Work Order ID 57592

Item Name: Basket Hoop

DESIGN #	DRAWN BY CP	DART AEROSPACE LTD HAWKESBURY, ONTARIO, CANADA	
CHECKED #	APPROVED #	DRAWING NO. D3166	REV. A SHEET 1 OF 1
DATE 02.07.10		TITLE BASKET HOOP	SCALE NTS
A	02.07.10	NEW ISSUE	
A1	04.04.08	38+/-1 WAS 36.0

DRAWING NO. D3166	TITLE BASKET HOOP	REV A1	DART AEROSPACE LTD ENGINEERING ORDER		D.E.O. NO. D3166-A-2	SHEET NO. 1 OF 1	SCALE NTS
DRAWN AJS	CHECKED L	MFG. APPR. M	APPROVED M/D		DE APPR. M		
DATE 08.12.11	DATE 08.12.15	DATE 08/12/15	DATE 08/12/16		DATE 08.12.16

D3166-1 BASKET HOOP

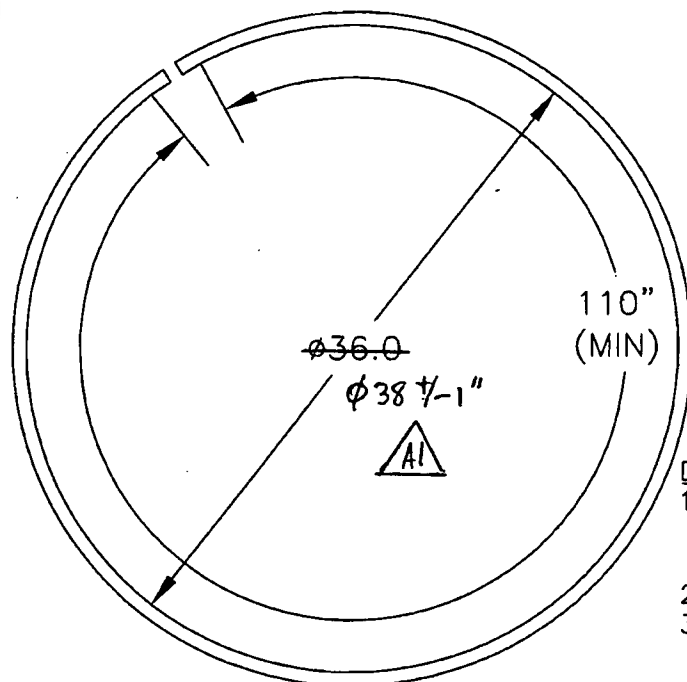
10.6 (REF, NEED 8.0 MIN)

1) MODIFY MATERIAL NOTE FOR D3166-1 AS SHOWN:

2) MODIFY MATERIAL NOTE FOR D3166-3 AS SHOWN:

REASON: SEE PAR 08-005

1) MATERIAL: AISI 304/316 SS, 3/4 X 3/4 X 0.065 WALL SQUARE TUBING,
60.00" LONG
REF. DART SPEC M304TS0.750W.065

1) MATERIAL: AISI 304/316 SS, 3/4 X 3/4 X 0.065 WALL SQUARE TUBING,
120.00" LONG
REF. DART SPEC M304TS0.750W.065
